May 17, 2006
JAFF-06-0079

**SUBJECT: James A. FitzPatrick Nuclear Power Plant
Docket No. 50-333
Response To NRC Request for Additional Information
Regarding FitzPatrick's Proposed Exemption Request
For Hemyc Fire Wrap (TAC No. MC7995)**

Attachment 1 to JAFP-06-0079
Entergy Nuclear Operations, Inc. – FitzPatrick
Docket No. 50-333
Response to Request for Additional Information (RAI)

Page 1 of 4
(Pull Box Photographs)

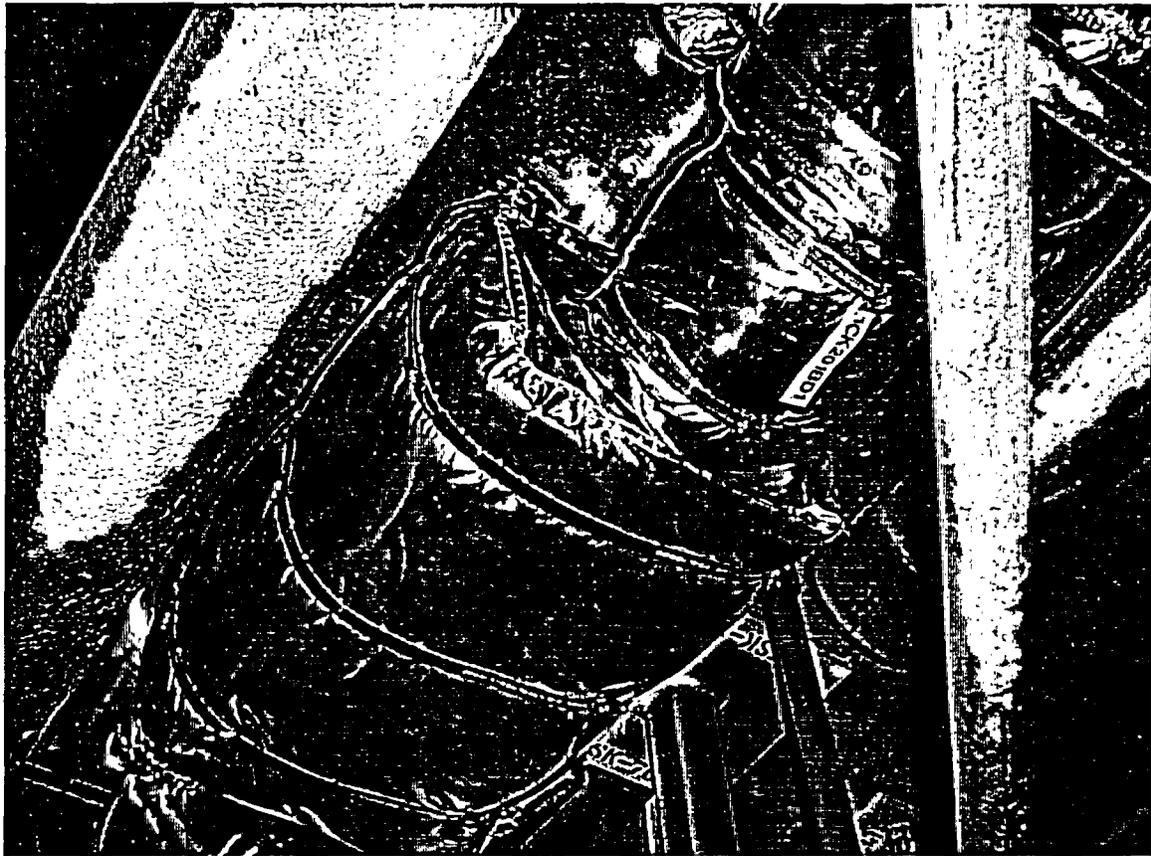
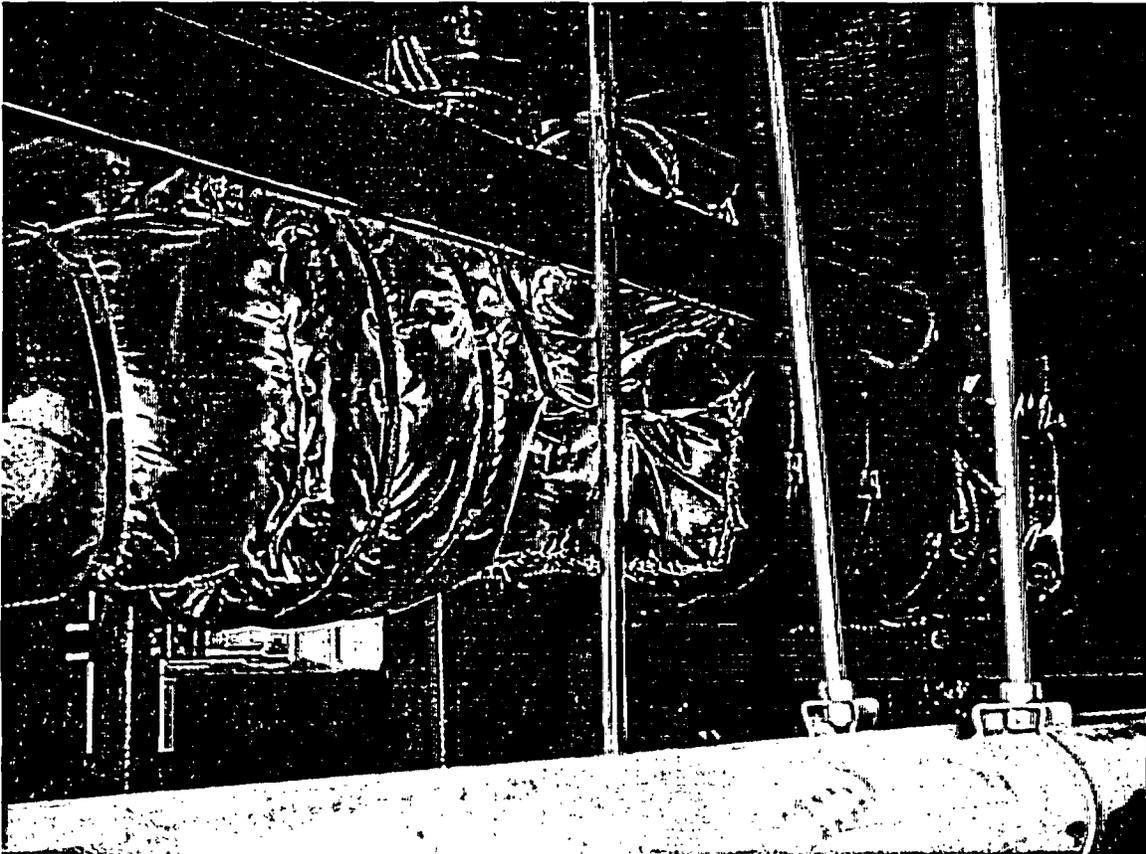
On page 2 of the licensee's submittal, the last paragraph states that the testing performed by the NRC supports the expectation that the installed configuration at FitzPatrick will meet or exceed a 30-minute fire rating. Although the NRC test results for a 4-inch conduit indicate failure as early as 33 minutes following the onset of a fire, when empty, and 43 minutes when full; other components of the raceway failed in less than 30 minutes. The unbanded junction boxes failed as early as 15 minutes into the event. The FitzPatrick configuration includes a pull box with stitched end pieces that are not banded. These end pieces, which could fail similarly to the stitched portion of the unbanded junction box that failed during the NRC test, are described as being secured by conduit wrap butted against them. Please provide a photograph or drawing of this pull box configuration, illustrating the security added at the end pieces. Also, please describe in detail the rationale for the statement that failure of these end pieces "is not expected to heat up the pull box to the point it would cause the cable to fail."

The banded junction box configurations tested by the NRC are somewhat different than the Hemyc wrapped pull box configuration present at JAF. The pull box is wrapped in manner that is better compared to the actual conduit or condulets tested versus the large junction boxes tested by the NRC. As seen in Attachment 2, the pull box at JAF is wrapped with a single piece of Hemyc, similar to a conduit, with stitched in place end pieces. The end pieces are partially secured in place with the Hemyc that is wrapped around the conduit. This configuration would prevent the end pieces from falling away even if the stitching of the end pieces were to fail. The un-banded junction boxes tested by the NRC had no attachments (i.e. Hemyc wrapped conduit) to the junction boxes, therefore, there were no items to prevent the wrap from falling away once the material shrunk and the stitching failed. Because the pull box at JAF has the 5 inch conduit protruding from both ends the actual area of the exposed end pieces is minimal as seen in the photographs (Attachment 2). The Hemyc on the pull box also has enough excess material such that if minimal shrinkage did occur the stitched joints would not fail.

The primary reason the stitched seam junction box tested by the NRC failed in less than 30 minutes can be attributed to the fact that the material contracted which caused the stitching to fail and subsequently the material pulled away causing direct flame impingement on the junction box. The banded junction box tested by the NRC did not fail until the 31 minute mark because the Hemyc was maintained in place for a longer period of time. In addition, the 31 minute failure was measured on the outside of the junction box (cold side of fire barrier), therefore, it is reasonable to assume the internal pull box temperature would be below the failure point of the cable beyond the 31 minute mark.

Additional industry testing on conduits using Hemyc made from actual Siltemp did not experience the same degree of thermal shrink as the Refrasil tested by the NRC. This new test information shows that the Hemyc material on the pull box will not shrink substantially enough to cause the stitched joints to fail. Additionally, the aluminized Siltemp used at JAF has better thermal reflectivity than conventional Siltemp. The improved reflectivity ensures the pull box is sufficiently wrapped to provide a 30 minute fire rating. In addition, there are no plausible fire hazards in the area of the pull box (Reference 4) that would subject it to a fire similar to what was tested. The presence of automatic full area suppression, in tray suppression, and full area detection further ensure the potential for an unmitigated fire is non-existent.

The information above validates the statement that the pull box is not expected to heat up to the point where the cable would fail based on a short circuit temperature of 482°F for the internal cables as previously discussed in the exemption request (Reference 2).
